MORTON SOUTHWEST COMMERCIAL SUBDIVISION PRELIMINARY OVERALL AREA DEVELOPMENT PLAN			
	M.W. CUDE ENGINEERS, L.L.C. CIVIL ENGINEERS & SURVEYORS <small>LOCATION: 10325 BANDERA RD., SAN ANTONIO, TEXAS 78250 TEL: (210) 681-3951 FAX: (210) 523-7112 URL: WWW.MWCUDE.COM</small>	DATE	REVISION
		DATE	REVISION
DRAWN BY: E.C.	DATE: 3/1/01	SHEET	
CHECKED BY:	JOB NO.: 10545	1 OF 1

Re: Morton Southwest Commercial

The City Staff Development Review Committee has reviewed Morton Southwest Commercial Subdivision Preliminary Overall Area Development Plan. Please note that your plan was not accepted, based on the following:

Morton Southwest Commercial Subdivision
Located on Loop 1604 south of Bowens Crossing

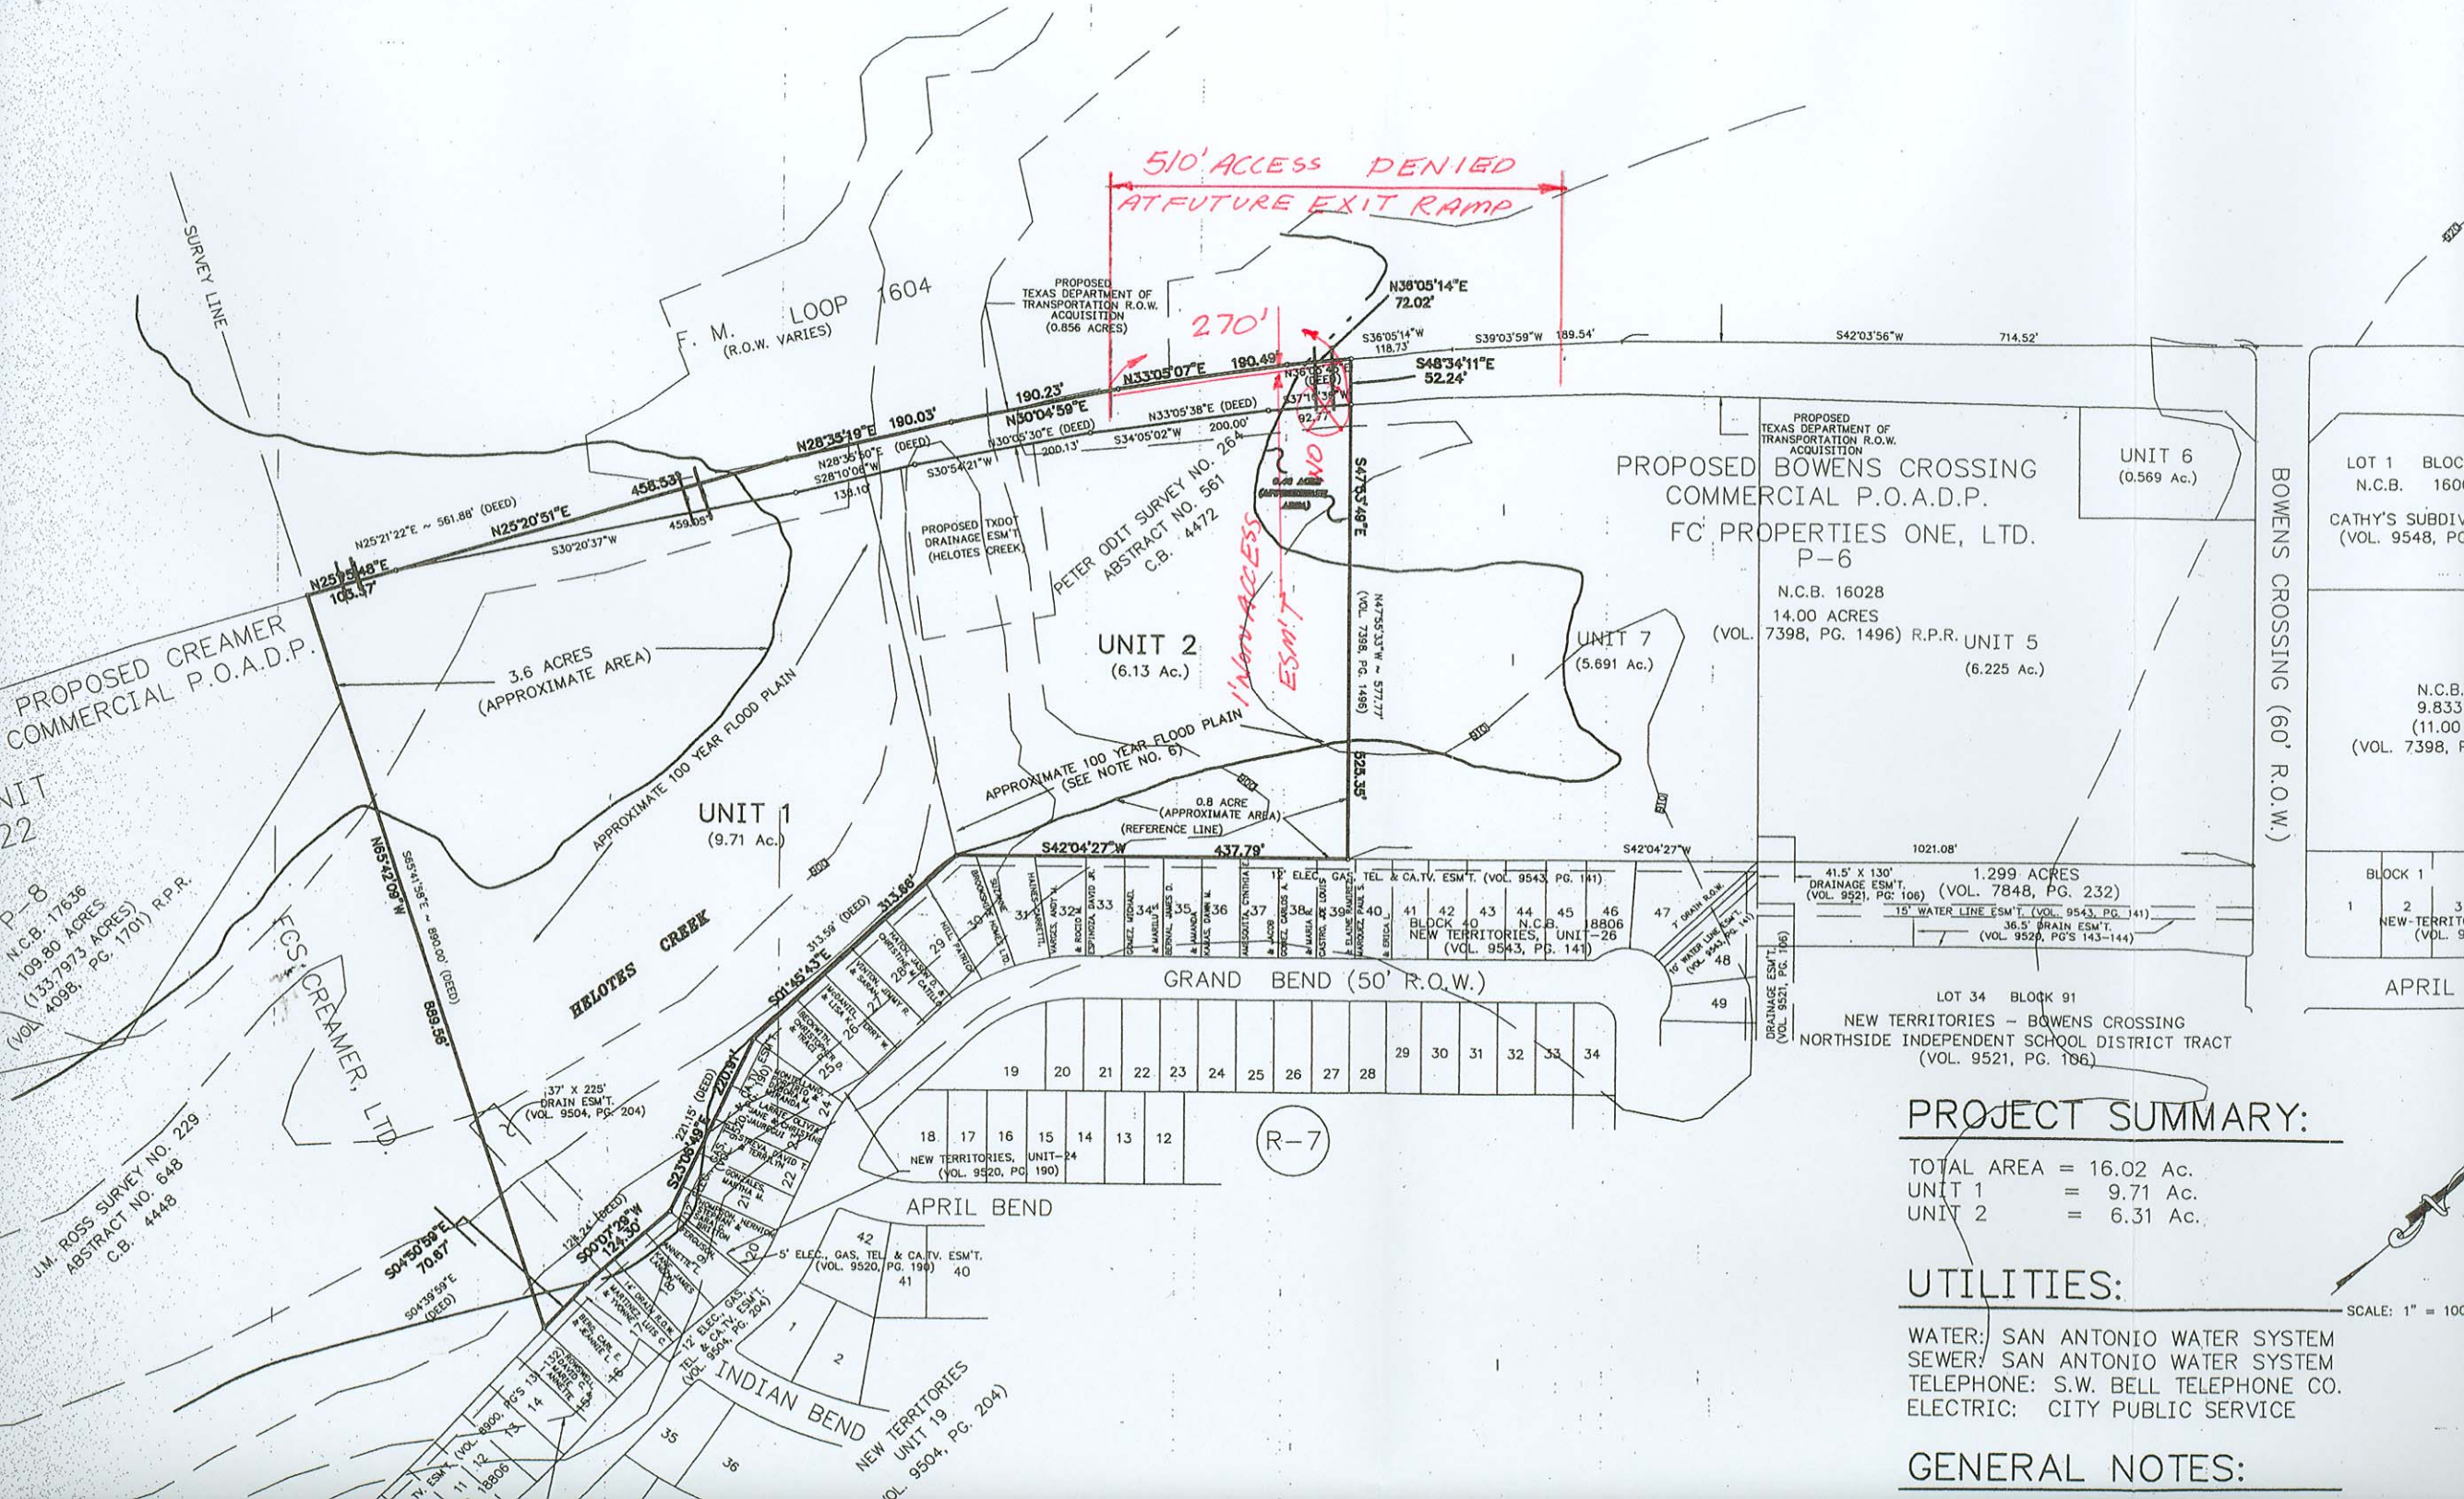
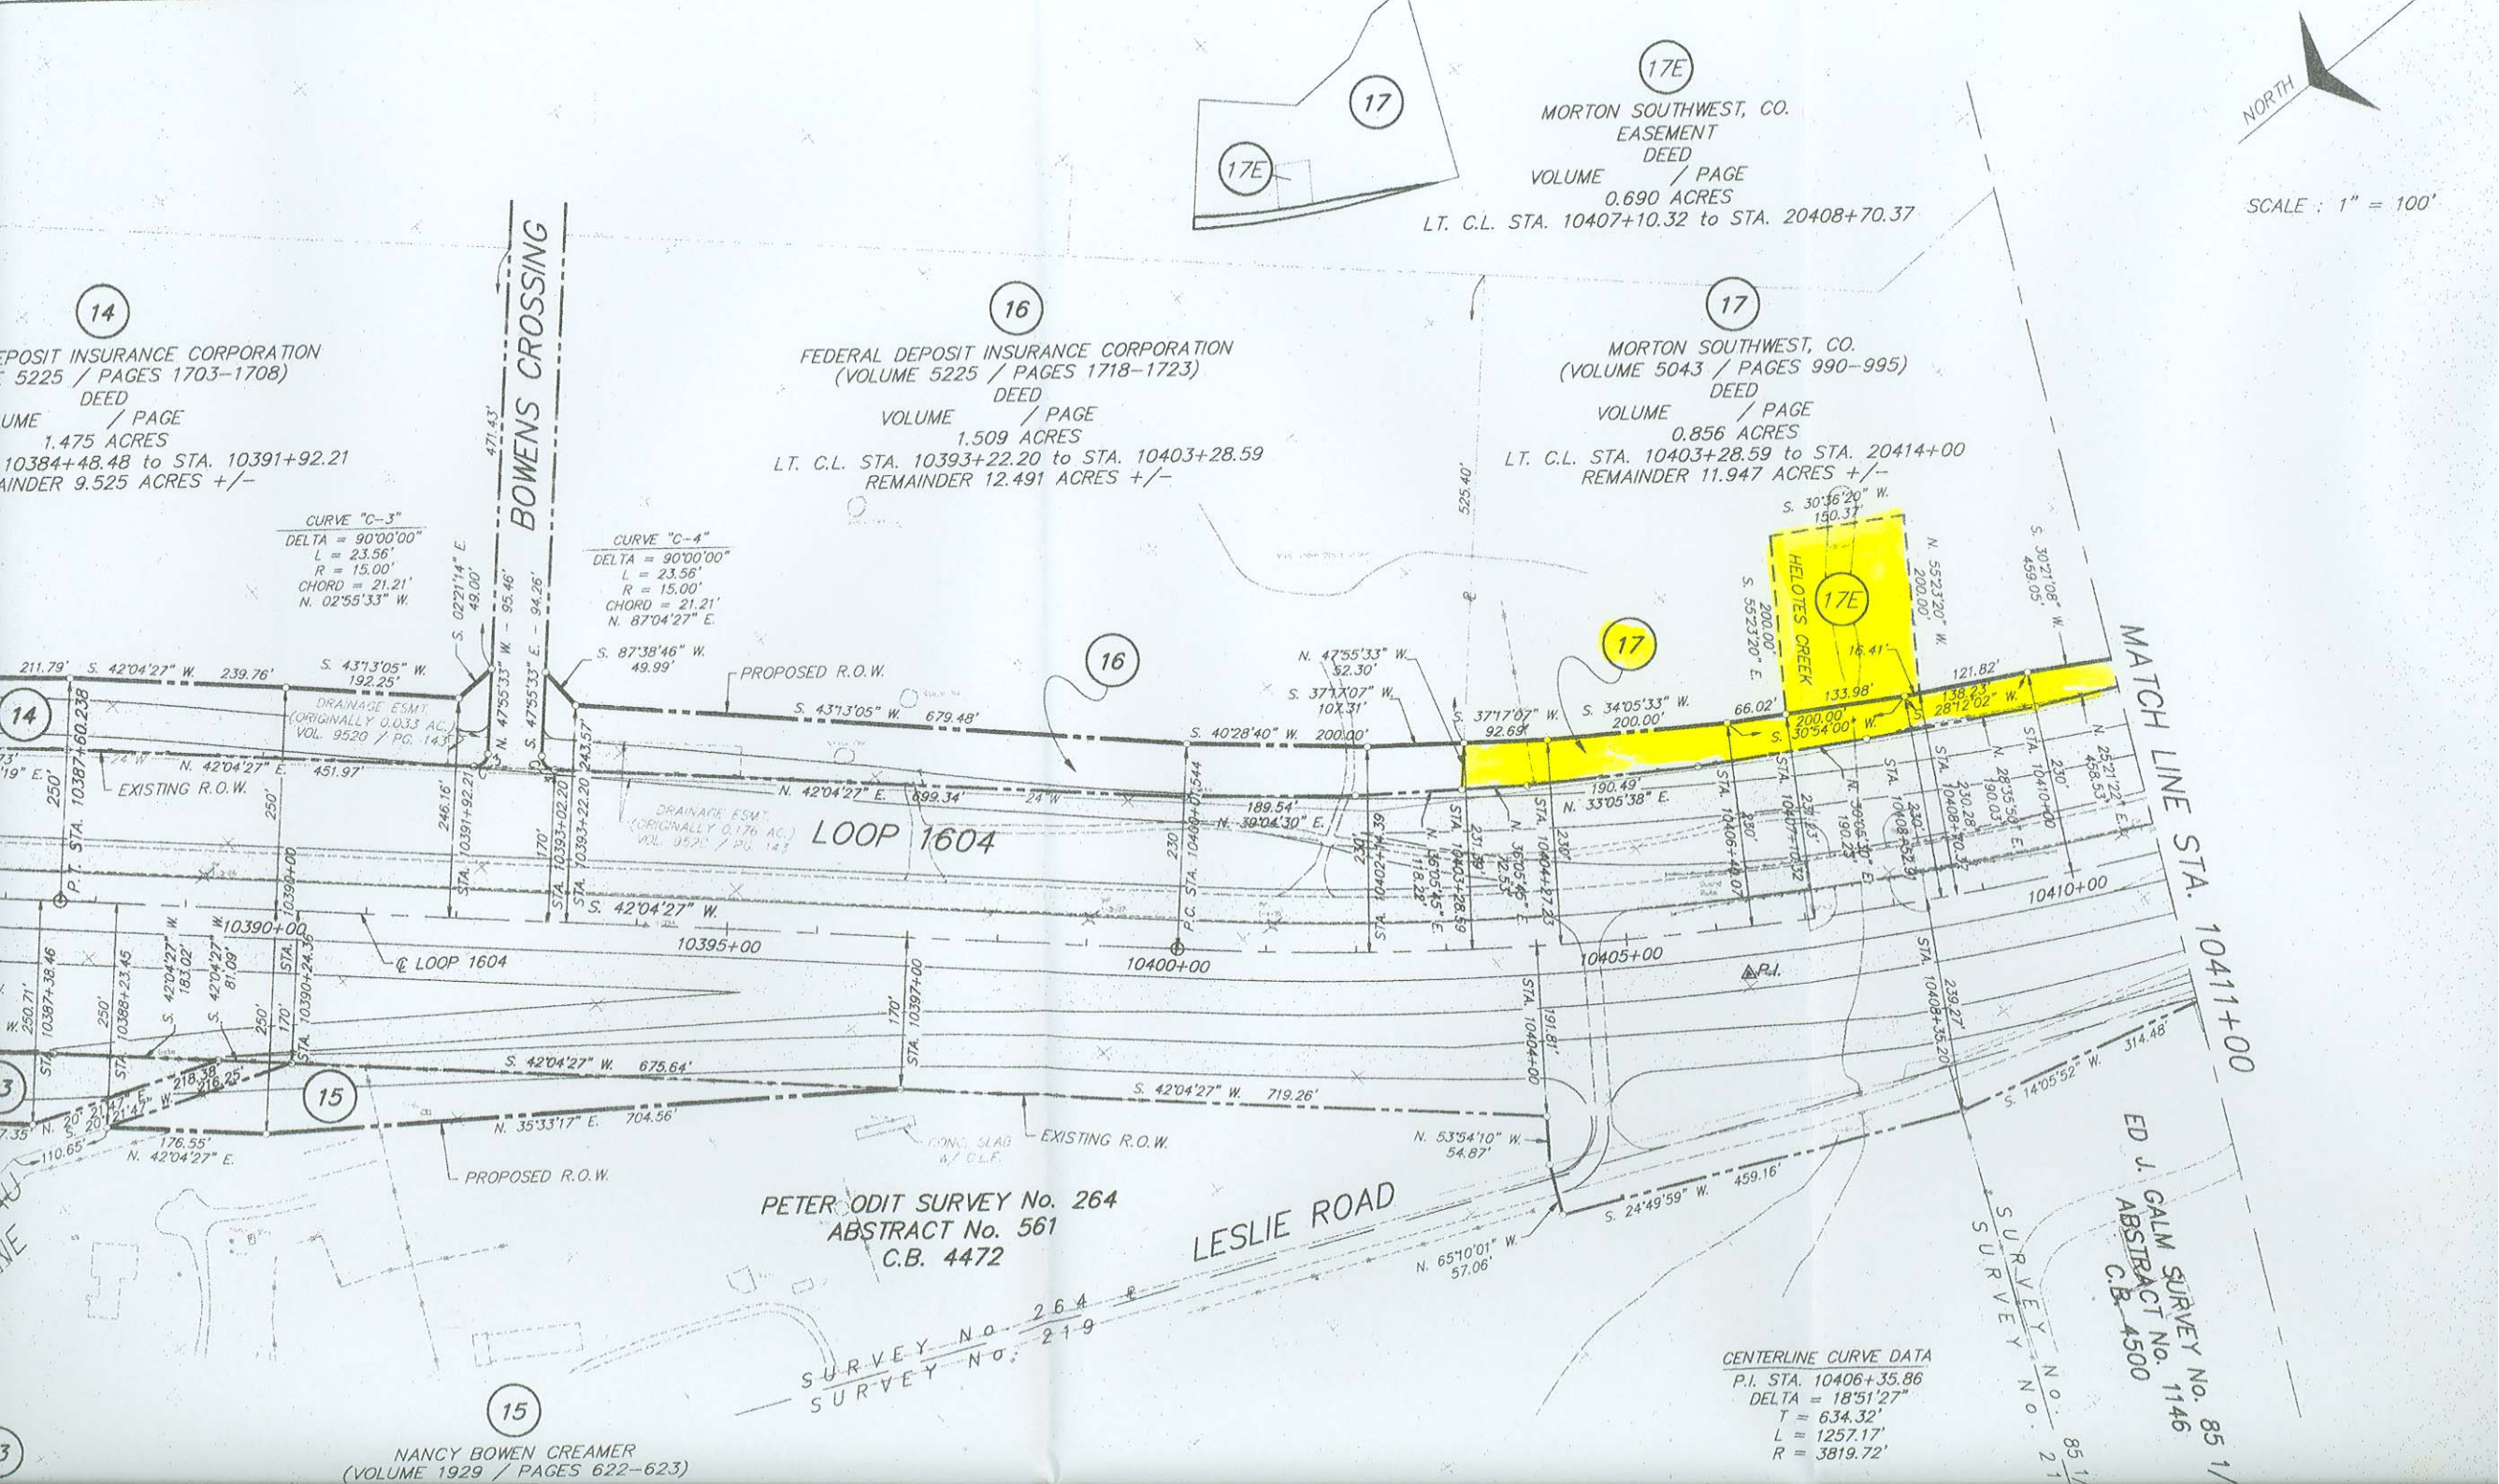
<u>P.O.A.D.P. Reviewed for:</u>	<u>Comments</u>
Noise Mitigation	For residential development directly adjacent to State ROW, the developer shall be responsible for adequate set-back and/or sound abatement.
R.O.W. Requirements	Require TxDOT right of way parcel number 17 and 17E, see attached layout.
Access Limits/Restrictions	Access to Loop 1604 will be as directed by "Regulations For Access Driveways to State Highways". TxDOT will permit a maximum combined total of two access points to Loop 1604. At the time of platting a 1' non access easement will be required along the frontage of Unit 2, as shown on the attached layout.
WPAP Requirements	None.
